**FINAL**  
**ENVIRONMENTAL IMPACT STATEMENT**

**Long-Term Management of  
Defense High-Level  
Radioactive Wastes**  
(Research and Development Program for Immobilization)

**Savannah River Plant**  
**Aiken, South Carolina**

**November 1979**

FIGURE IV-1. Radionuclide Composition of SRP Waste (0 to 20 years after irradiation)

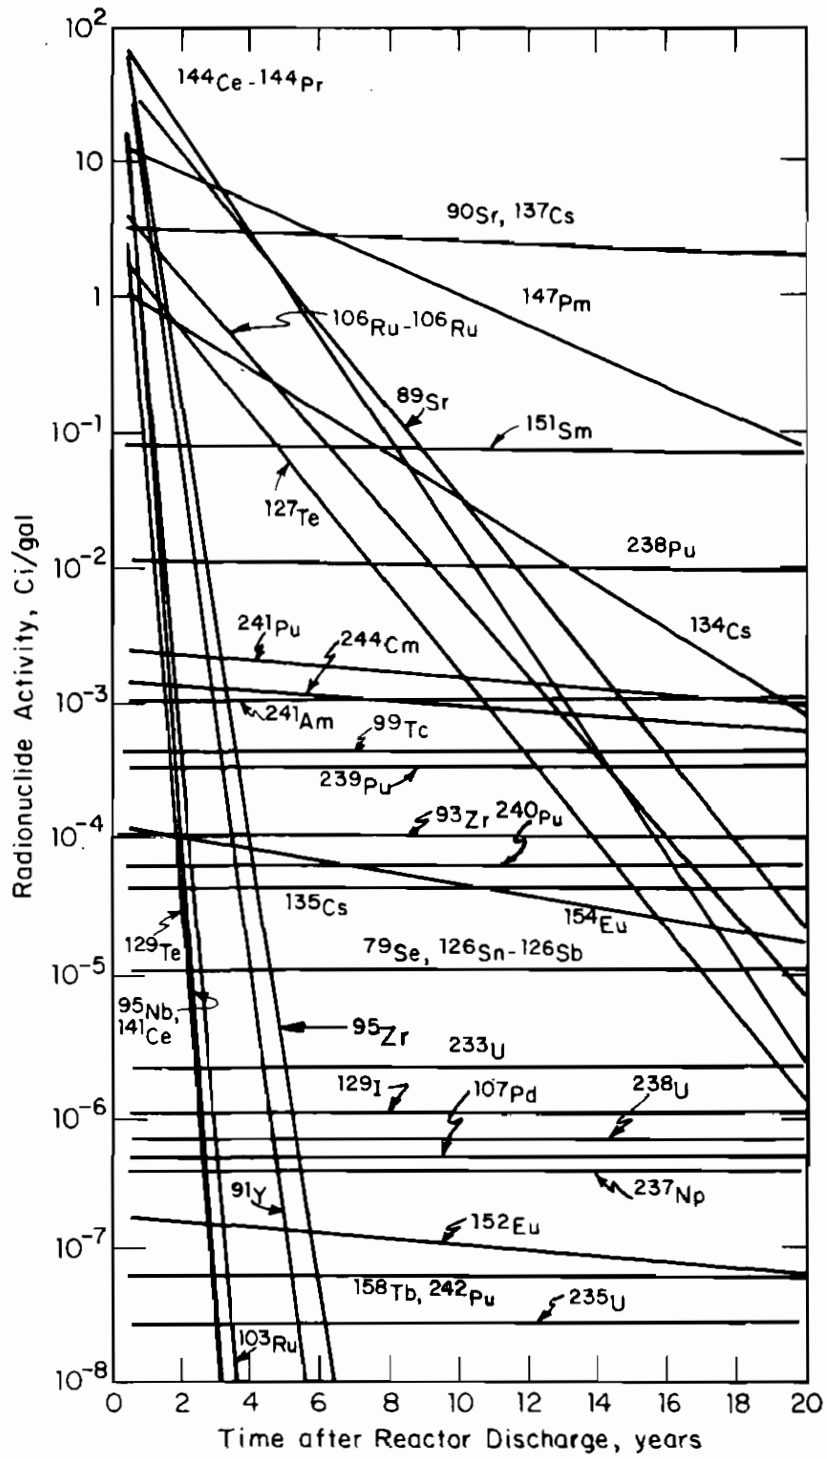
L-16 1) Page IV-5, Figure IV-1:

Figure 1: EPA has revised Figure III-3 (page III-5) from the source document to show the local mylonite zones and the fault between the Triassic sedimentary rock and the Metamorphic basement rock. The Tuscaloosa Aquifer is in the formation labeled as "Nonmarine Sediments of Late Cretaceous Age."

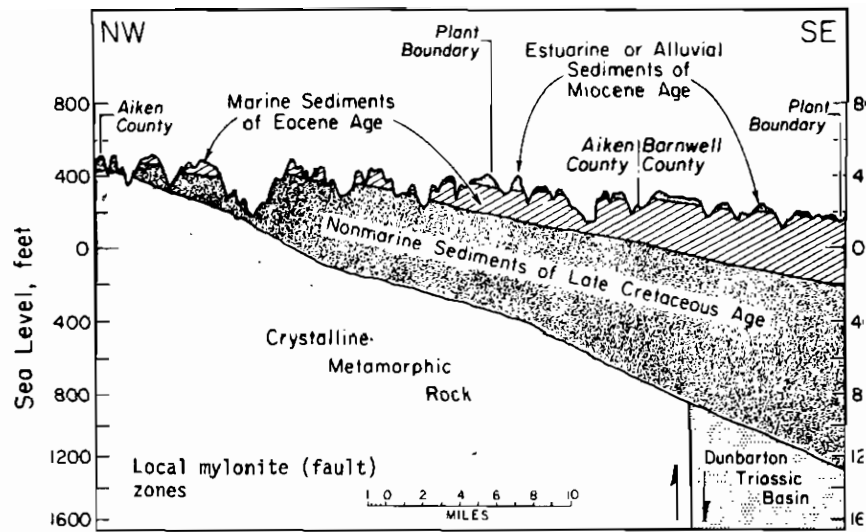
L-13 The basement rock beneath the Savannah River Plant is described in the draft EIS as crystalline metamorphic rock grading into Dunbarton Triassic Basin rock to the southeast. A vertical geologic cross section to a 2,000 foot depth is depicted in Figure 1 and shows approximately 1000 feet of unconsolidated sedimentary rocks overlying older crystalline metamorphic and Triassic sedimentary basement rock. The contact between the older crystalline metamorphic rock and younger sedimentary Triassic basement rock is a normal fault and predates the Triassic deposition. The presence of

L-14 The 500 foot thick Tuscaloosa aquifer overlying the basement rock is one of the most important aquifers in the southeastern United States (See Figure 1). A saprolite clay of an average of 70 feet in thickness separates the basement rock from the aquifer, but locally this clay is absent. The investigative report of the National Academy of Sciences (1972) assumes that water from the basement rock is being transmitted upward into the Tuscaloosa aquifer at a rate of 0.002 gpd/ft<sup>2</sup> where clay is present, but at 0.0035gpd/ft<sup>2</sup> wherever the clay may be absent. To date, no absolute hydraulic separation of the basement rock from the Tuscaloosa aquifer has been proven by the chemical evidence available and it may be presumed that movement of waters between the basement rock and the aquifer occurs in accord with existing permeabilities and hydraulic gradients. The possibility of aquifer and basement water mixing, involving potential high-level nuclear waste, presents a potential risk of contamination in the Tuscaloosa aquifer and the biosphere.

The gross separation of the waters of the coastal plain aquifers and those of the bedrock are shown by: (1) the abrupt discontinuity in their chemistries TDS  $\approx$  30 mg/l at the base of the coastal plain aquifer and 6000 mg/l in the crystalline metamorphic rock; (2) pumping about 1500 gpm in each of two plant areas continuously for 27 years has not caused a decline in hydraulic pressure in the crystalline rock; (3) a year-long pumping test in the crystalline rock showed no indication of leakage through the saprolite; (4) a large amount of helium has accumulated in the waters of the crystalline rock which could not have accumulated if there were even minor leakage from the metamorphic rock. Therefore, although it has not been conclusively demonstrated, the water mixing potential is considered to be extremely low. Migration of radionuclides from the cavern was considered in the preparation of the EIS and the potential environmental impact was determined to be insignificant.

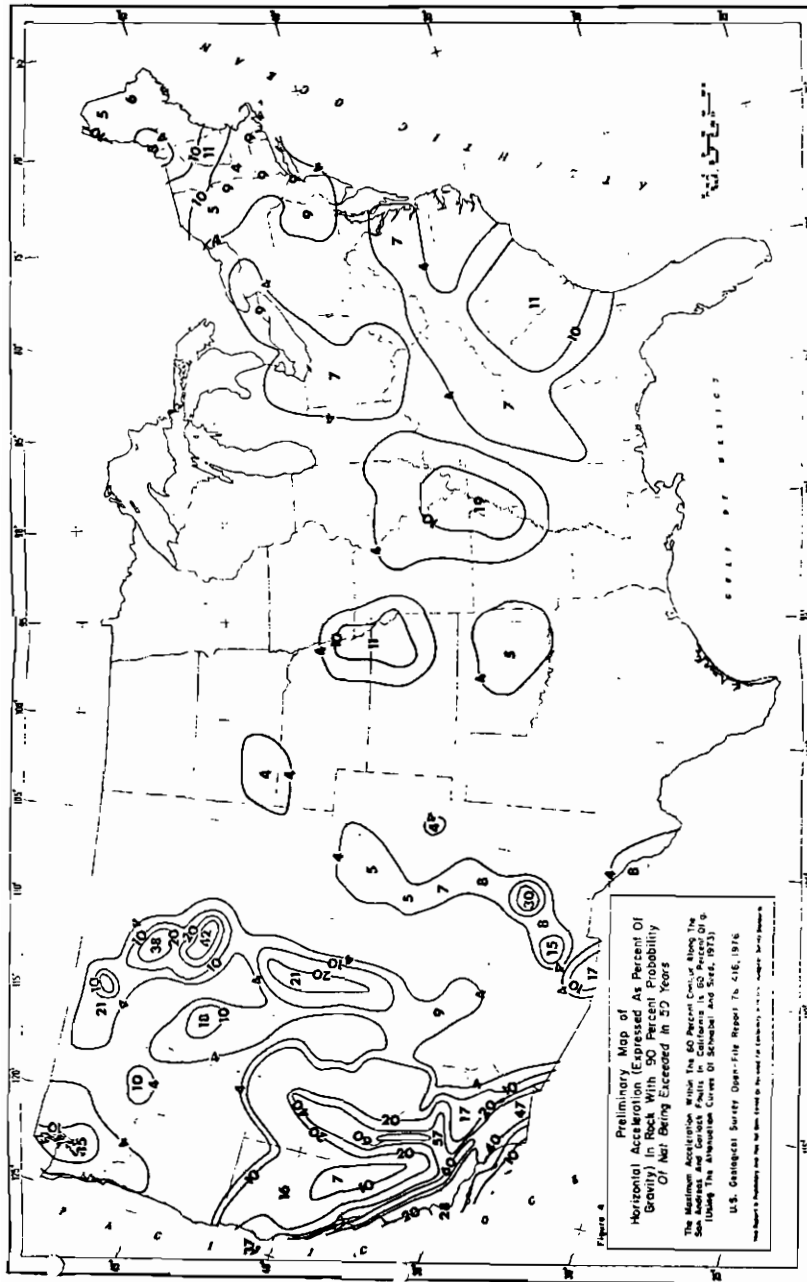
L-15 A map of earthquake hazard developed by Algermissen and Perkins, 1977, is depicted in Figure 2. Although the hazard in the East is lowered by the relative infrequency of large earthquakes, the total time in the last 250 years is actually greater than that in the West. As shown in Figure 2, the highest number in the East centers around Charleston, S.C., which in 1886 was the site of an earthquake of Intensity X on the Modified Mercalli Scale. While the cause of this severe earthquake is speculative as to origin, the earthquake epicenter lies but a few miles from the Savannah River Plant site.

The fact that the metamorphic bedrock is locally faulted and fractured makes bedrock disposal, even in the Triassic sedimentary rock, and unviable option at SRP. At a minimum, these geological problems should be discussed more adequately in the final EIS.

As stated on page III-11 of DOE-EIS-0023, the epicenter of the Charleston Earthquake of 1886 was about 90 miles from SRP. All investigations of known faults in the metamorphic bedrock have shown that they are noncapable faults. The options for storage of waste in bedrock assume that the cavern would be constructed in nonfaulted bedrock. Extensive field study would be required to determine whether disposal in a nonfaulted area is in fact feasible but studies to date do not preclude this possibility.
